City of Fremont
Newaygo County, Michigan
Wastewater Lagoon Improvements

PROJ #2023755002.00

ADDENDUM #1

DATE:07/31/23

Sheet:
G7

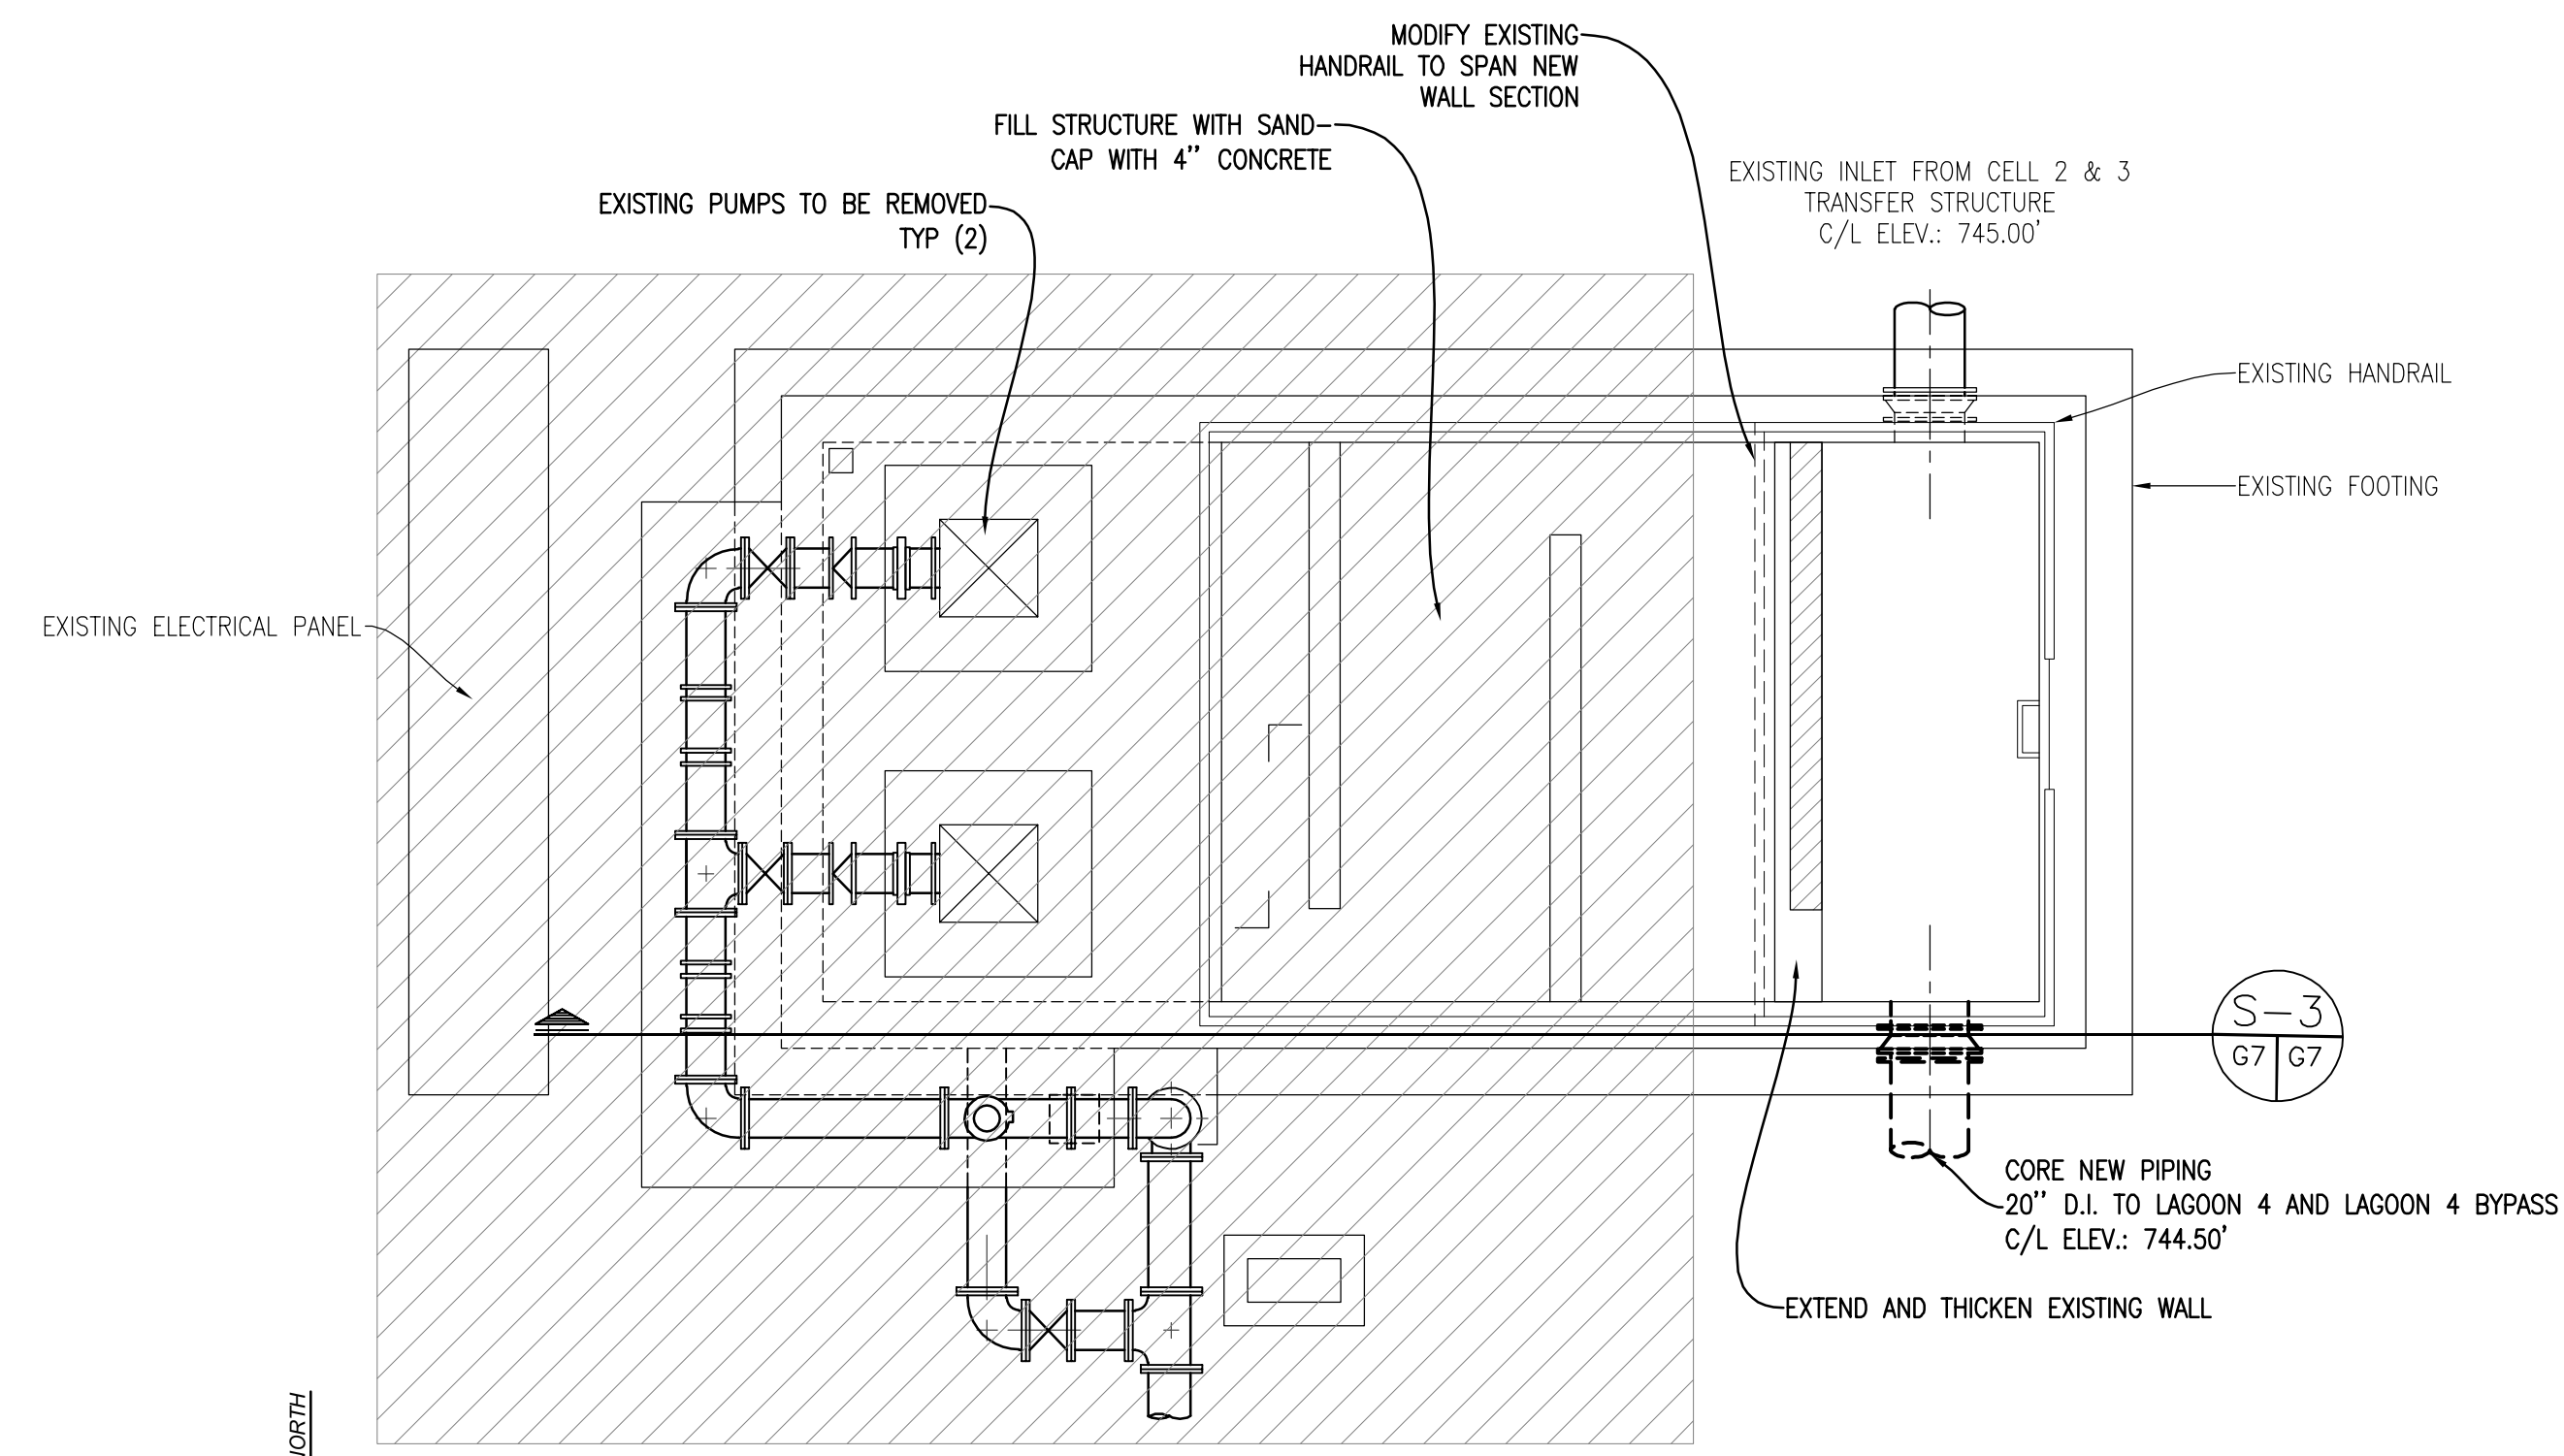
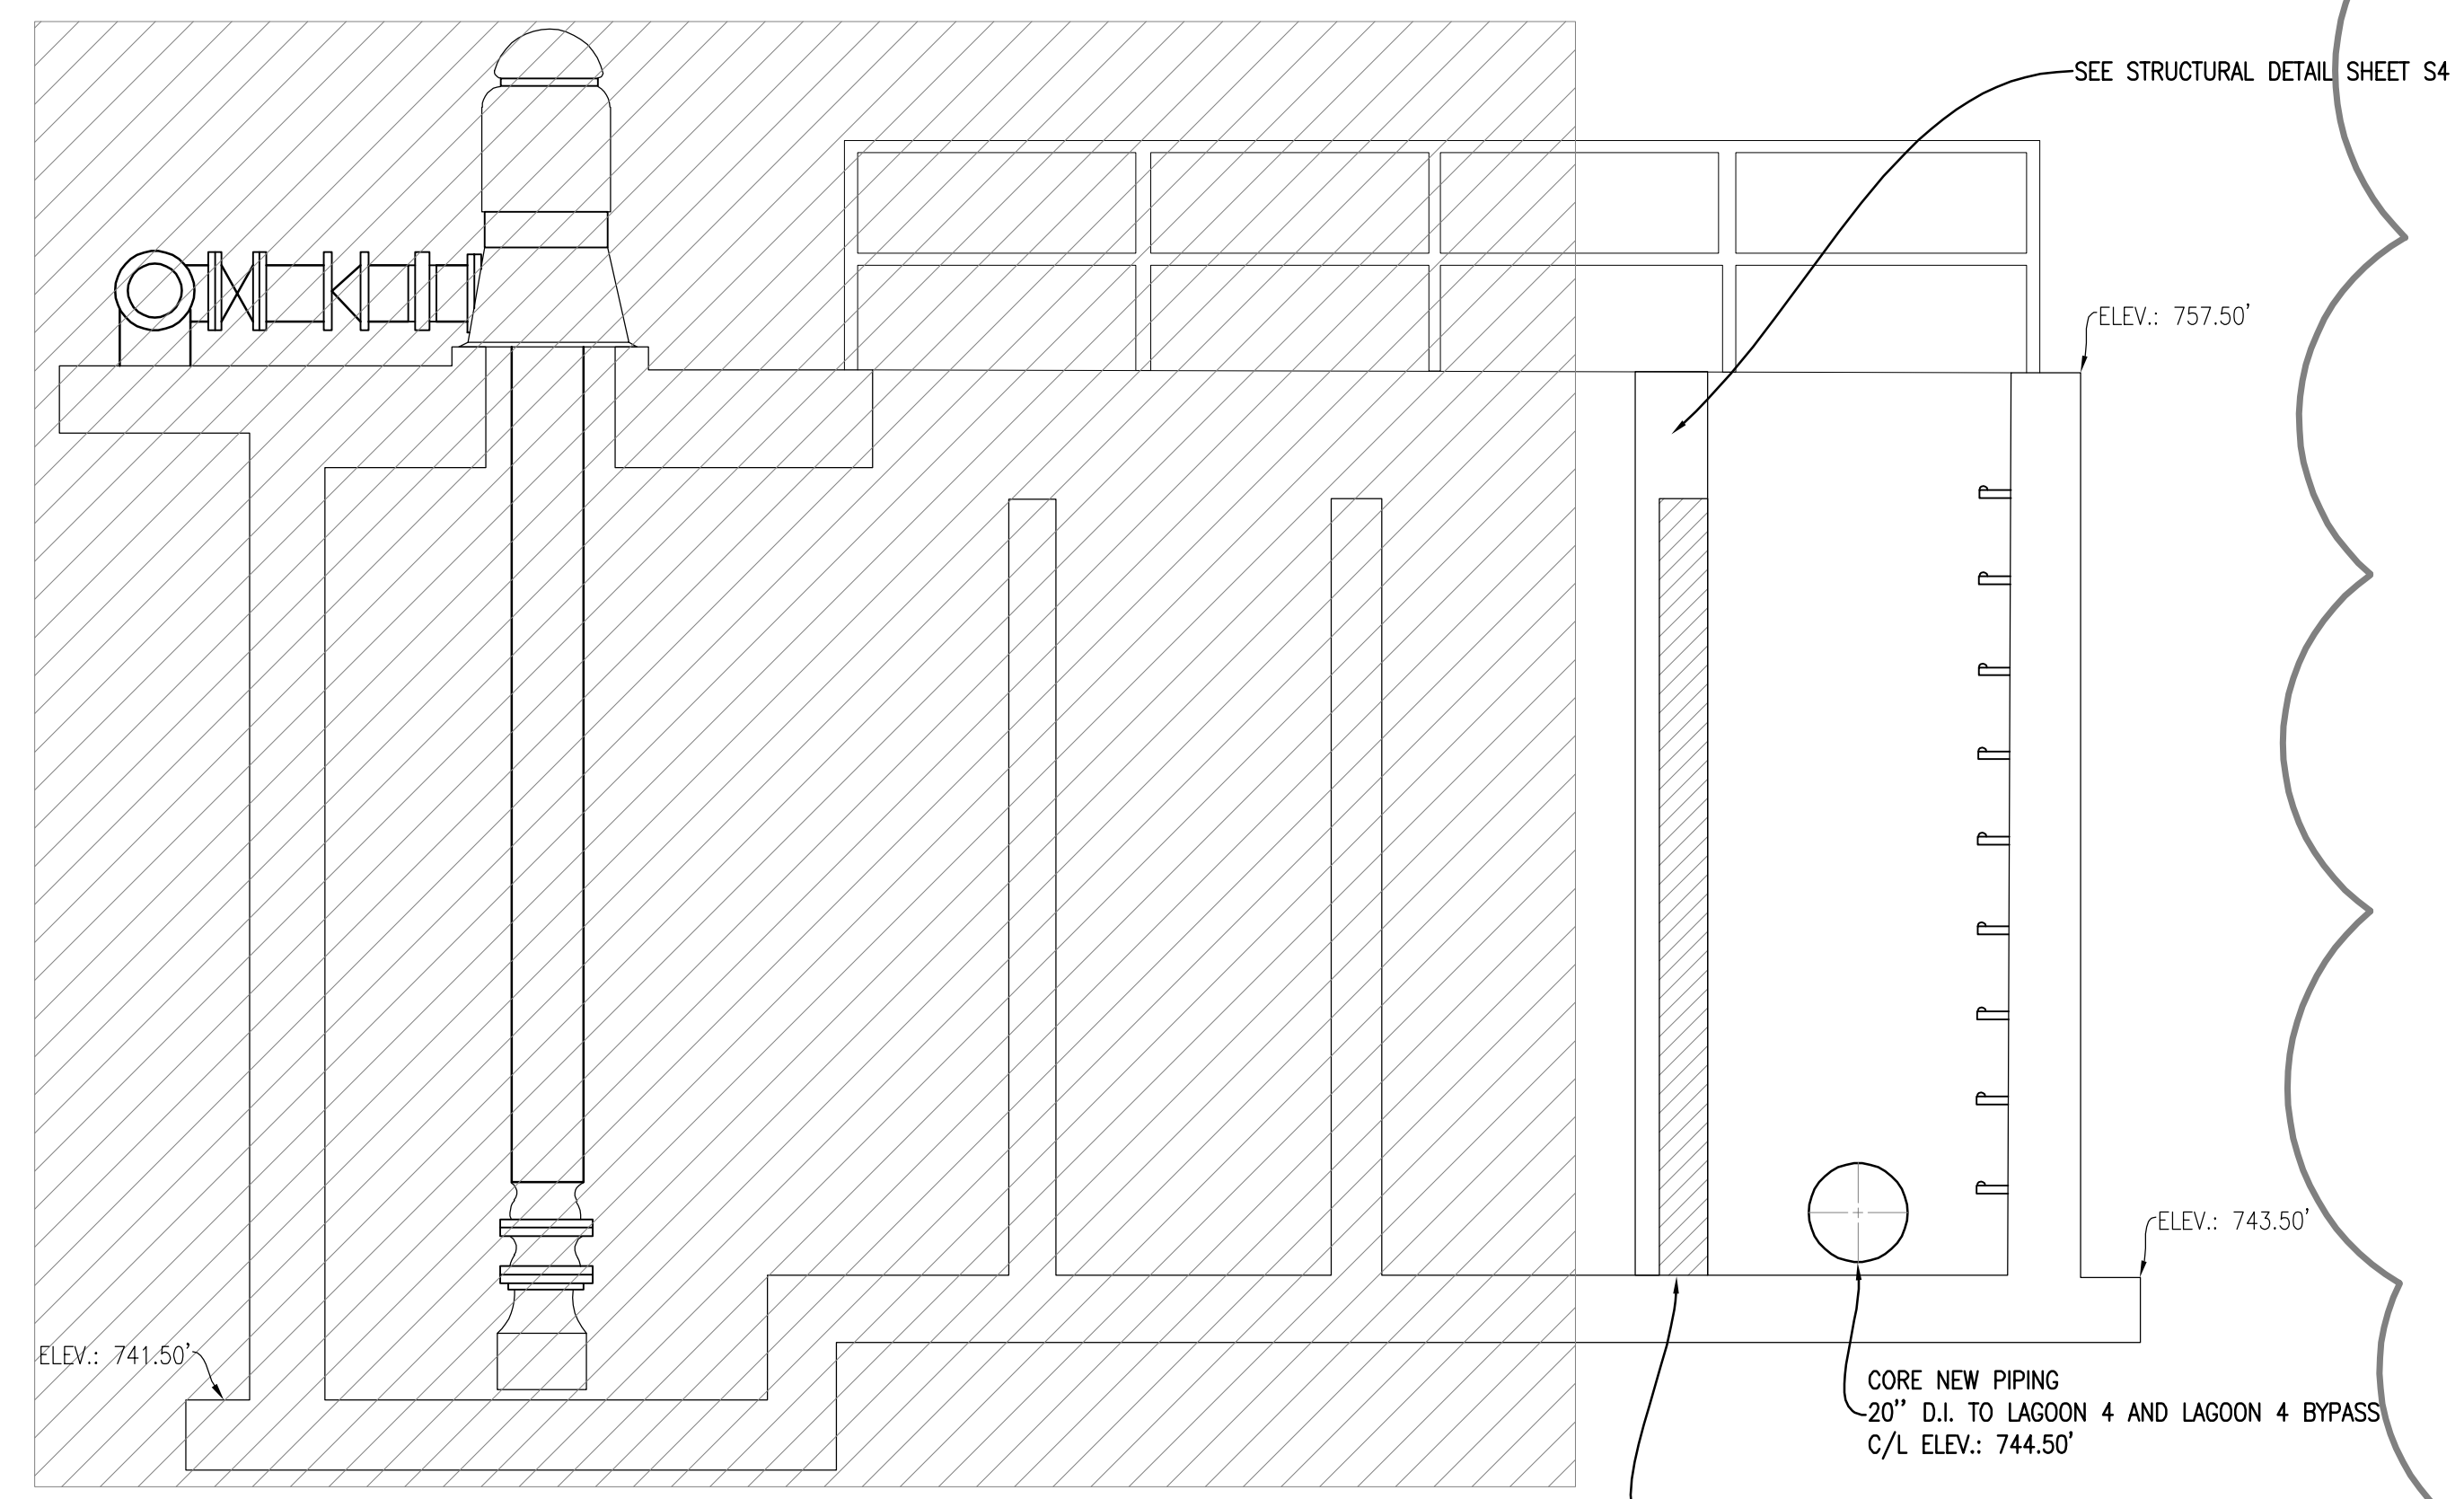
6. Sheet G7: Are any record drawings or manufacture/model# of existing sluice gates available for review?
Record drawings indicate the existing sluice gates are Armco Steel Corporation Model 55-20 with an 18” diameter.

1. **G5: REPLACE** with attached: Lagoon 4 By-passing piping valves to be gate valves with box, lid and telescopic extension stem.
2. **G7: REPLACE** with attached: Replacement of existing sluice gates has been eliminated from the project.
3. **G8: REPLACE** with attached: Irrigation Pump Station Plan: 10” **Ball Plug** Valves
4. **G10: REPLACE** with attached: Overflow pipe to be 20” CPP, Road Gravel to extend over anchor trench to top of basin stone anchor system, in addition to access road as shown on plans. Sand cover to be 12” with 6” stone.
